SERVICE BULLETIN

Service Bulletin No.: DA20-92-04 Rev 0

Title: Installation of Photo luminescent Placards

Figure 1:

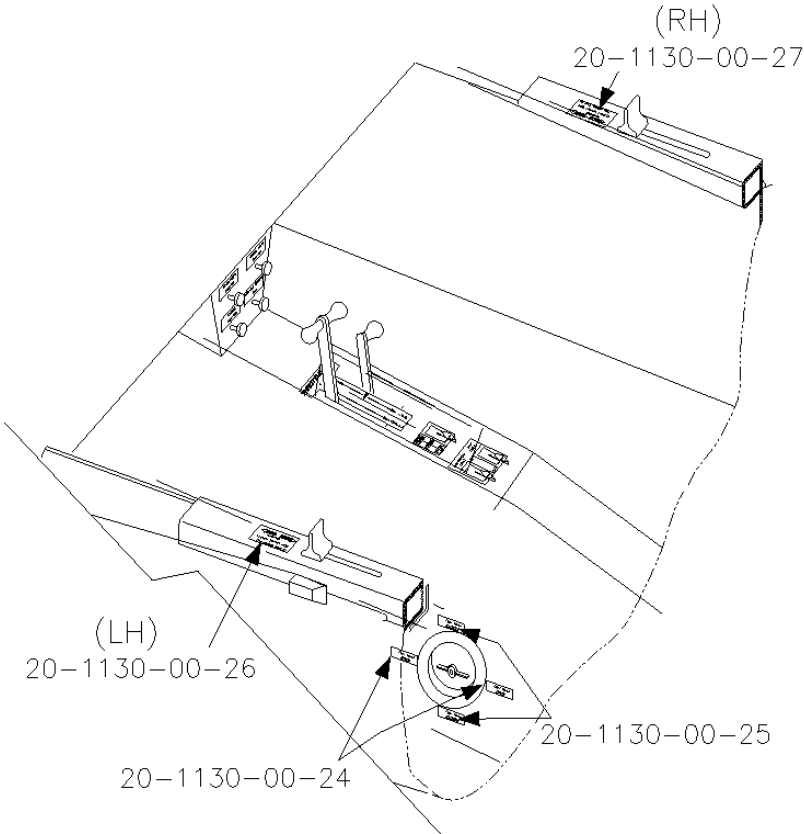
- 10.1 Replace the following standard English internal placards with illuminated English placards as shown in Figures 1 and 2.

Figure 3:

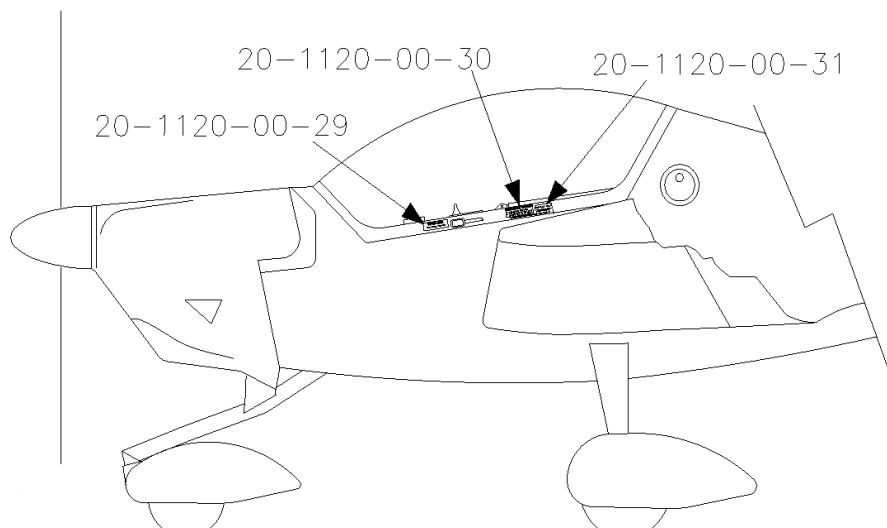
- 10.1** Replace the following standard English external placards with illuminated English placards as shown in Figures 3 and 4.
